## **Amendment and Response**

Serial No.: 10/577,173

Title: SEMICONDUCTOR DEVICE WITH PLASTIC PACKAGE MOLDING COMPOUND, SEMICONDUCTOR CHIP AND LEADFRAME AND METHOD FOR PRODUCING SAME

## **REMARKS**

**FIG 2**

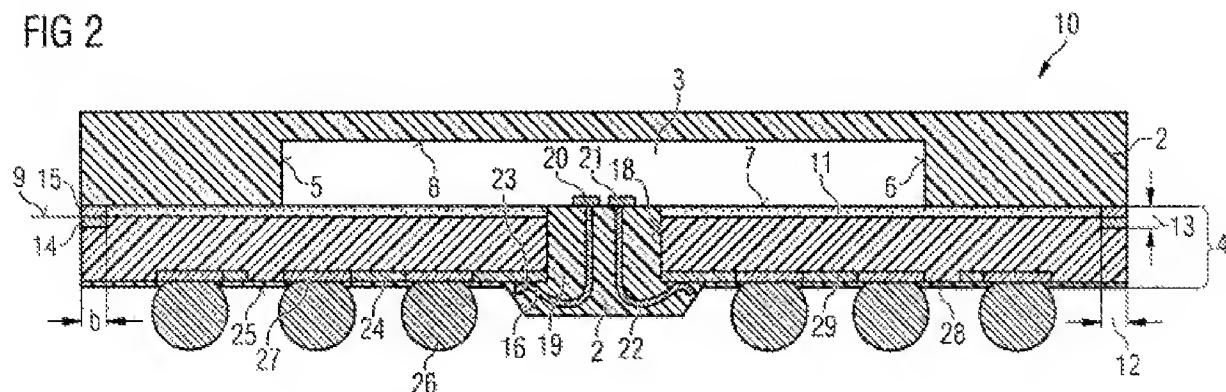
The Office Action objected to the drawings under 37 CFR 1.83(a), noting, “the drawings must show every feature of the invention specified in the claims. Therefore, the plastic molding mechanically decoupled must be shown....” Office Action at p. 2.

Thus, the elastic adhesive layer is arranged between the plastic molding compound and leadframe so as to mechanically decouple the upper region from the lower region. Applicants respectfully submit that this feature is fully illustrated in the drawings as filed. For example, Figure 2 of the application is reproduced below.

As shown in Figure 2, an elastic adhesive layer 11 is situated between a leadframe 4 (lower region) and a plastic package molding compound 2 that embeds a semiconductor chip 3

(upper region). The adhesive layer 11 does not extend to the peripheral regions of the device. A metal layer 13 is situated around the peripheral regions. Thus, the adhesive layer 11 and the metal layer 13 shown in Figure 2 separate and mechanically decouple the plastic package molding compound 2 from the leadframe 4. In this manner, the plastic package molding compound 2 and embedded chip 3 are not directly arranged or anchored on the leadframe 4, but are connected to the leadframe 4 by the adhesive layer 11 and the metal layer 13. As taught in the specification, this structure illustrated in Figure 2 functions to mechanically decouple the chip 3 and the plastic package molding compound 2 from the leadframe, which is beneficial with respect to thermal expansions of these components and associated thermal stresses. *See, e.g.*, Application Specification at p. 3, ll. 19-25; p.4, ll. 19-30 and p. 7, l. 19 – p. 8, l. 25).
